ADDENDUM NO. TWO

PROJECT TITLE: Bradley Park ESC Auto  
Shop Roof Replacement

ISSUANCE DATE: June 13, 2012

**R-3R** GUTTER EDGE DETAIL

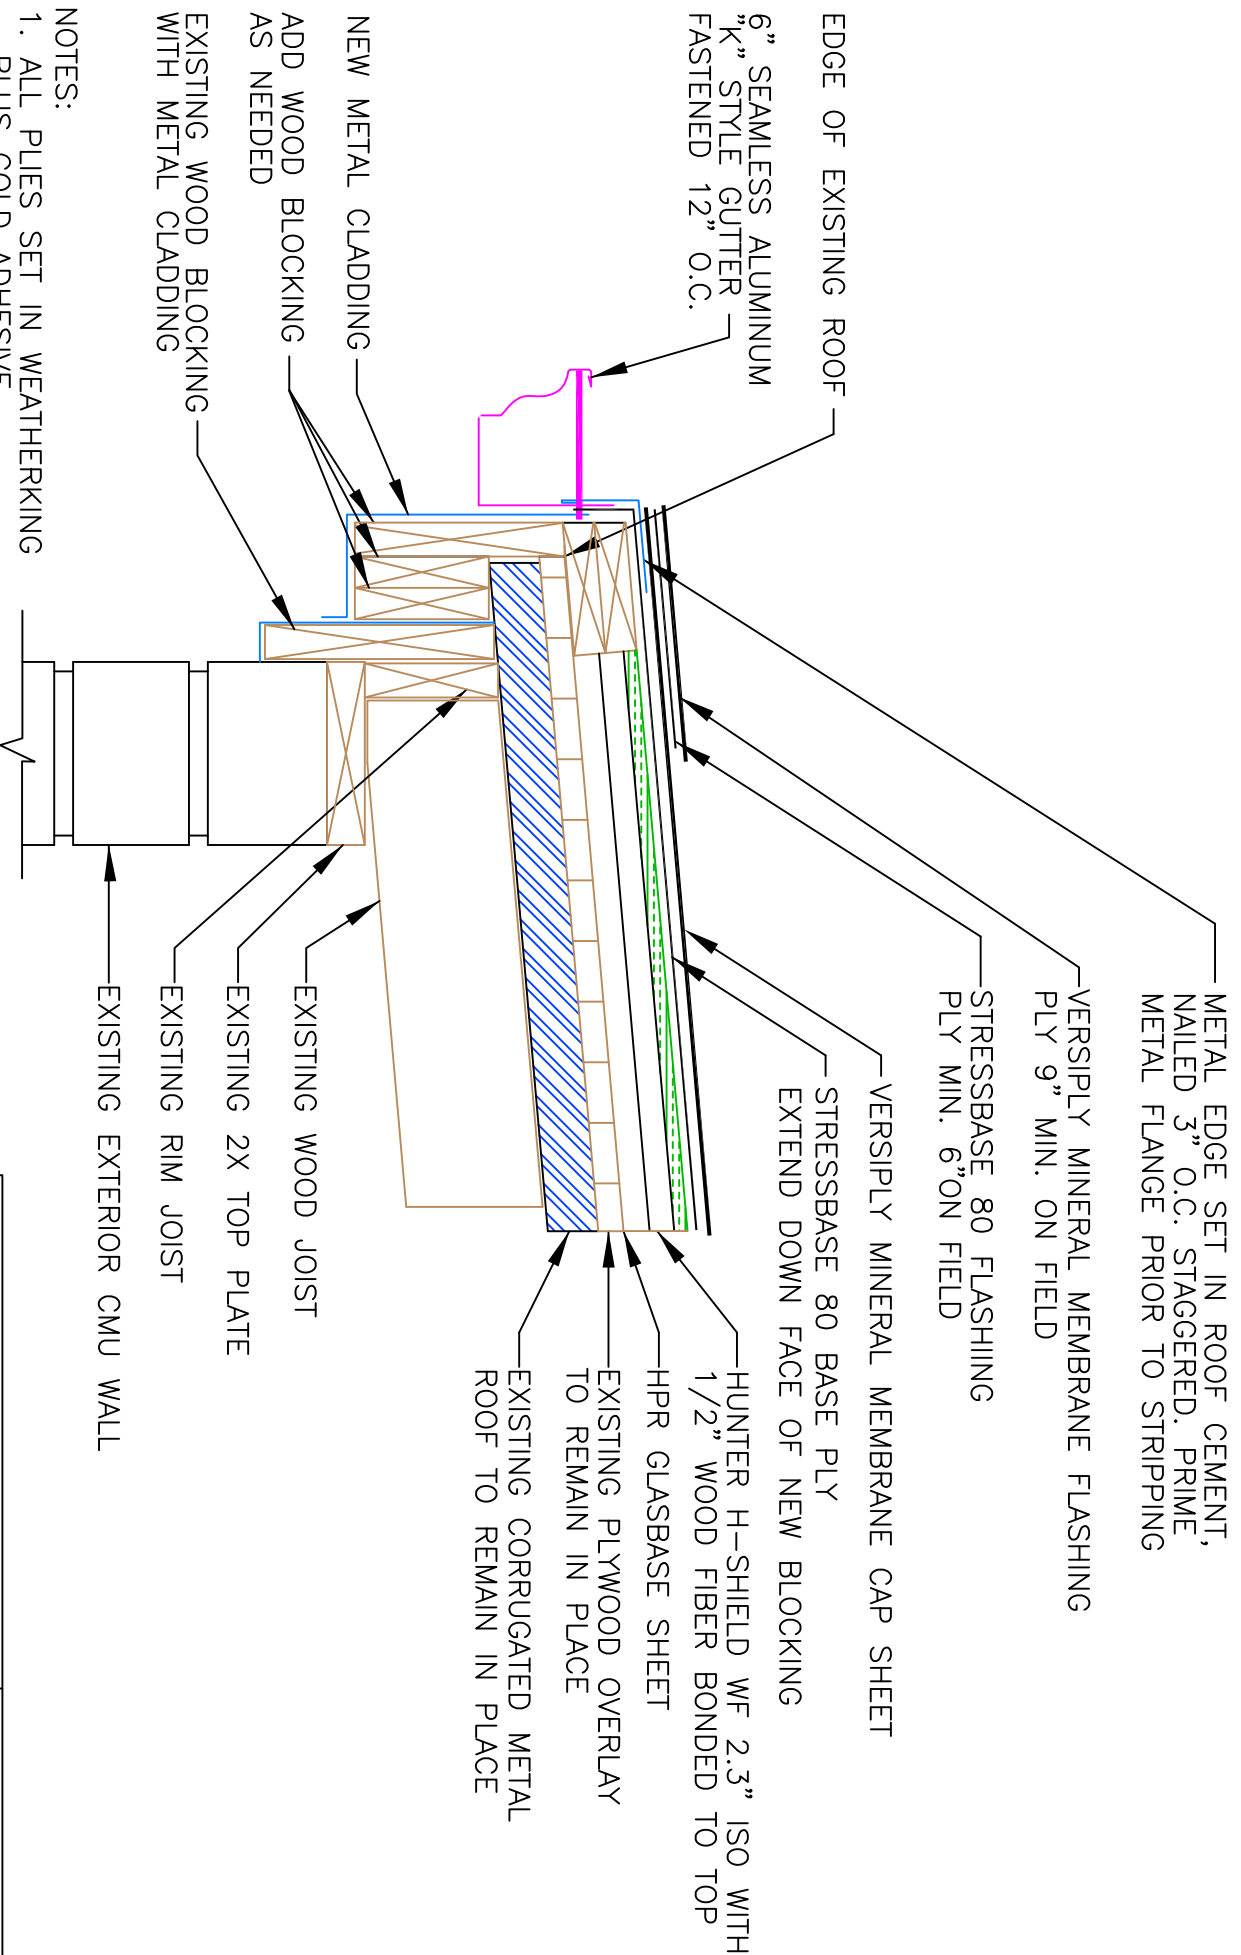
1. Disregard all reference to ½" High Density Wood Fiber and replace with Hunter H-Shield WF (or equal). Thickness shall be 2.3" of ISO insulation with ½" HD Wood Fiber bonded to top surface.
2. Drawing R-3 Gutter Edge Detail is replaced with Drawing R-3R (revised). Note changes to wood blocking at roof edge and placement of metal edge.
3. Drawing R-4 Exhaust Fan Curb Detail- Replace reference to ½" wood fiber with Hunter H-Shield WF 2.3" ISO with ½" wood fiber top.
4. Drawing R-6 - Replace reference to ½" wood fiber with Hunter H-Shield WF 2.3" ISO with ½" wood fiber top.
5. Drawing R-7 Rake Flashing Detail
